Monthly Specification Update

Intel® Server Board S5520UR

Intel Order Number E69054-001

March 2013

Figure 1. Removing the Heatsink

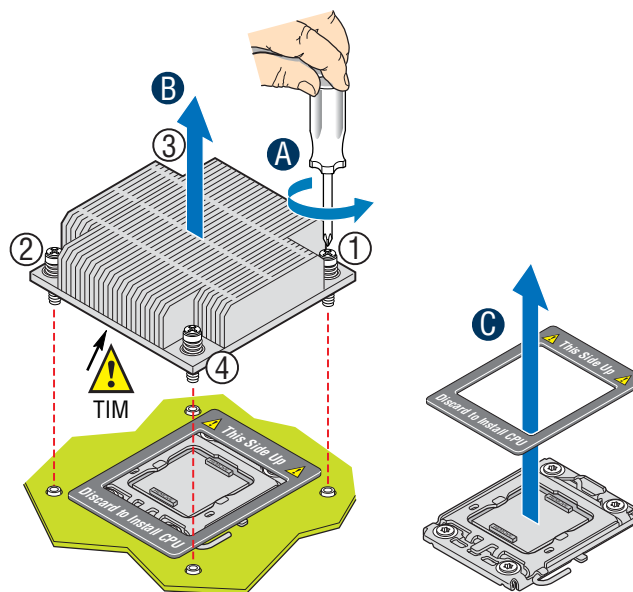
1. Proper Heatsink Installation and Removal Instructions are missing from Service Guide

- Problem:** The current documentation does not properly describe the installation and removal of the heatsink. Careful insertion and removal of the heatsink is required to prevent damage to the heatsink screws or backplate.
- Implication:** There is a possibility of damage to the heatsink if proper steps are not followed.
- Status:** Corrections incorporated into the latest version of the following Service Guides:
- Intel® Server System SR1600 Service Guide (Intel Order Number: E52880-003)
 - Intel® Server System SR1625 Service Guide (Intel Order Number: E52881-003)
 - Intel® Server System SR2600/SR2625 Service Guide (Intel Order Number: E51243-003)
- Workaround:** Perform the steps outlined below for installation and removal of the heatsink to avoid damage.

1. Loosen the four captive screws on the heatsink corners in a diagonal manner according to the numbers shown in figure 1 as follows:
 - Starting with the screw at location 1, loosen it by giving it **two rotations** in the anticlockwise direction and stop. (**IMPORTANT:** Do not fully loosen.)
 - Proceed to the screw at location 2 and loosen it by giving it two rotations and stop.
 - Loosen screws at locations 3 and 4 by giving each screw two rotations and then stop.
 - Repeat steps 1a through 1c by giving each screw two rotations each time until all screws are loosened.
2. Do one of the following:
 - If removing the heatsink for the first time, do the following:
 - i. Lift the heatsink from the board.
 - ii. Remove and discard the spacer (see letter "C" in figure 1).
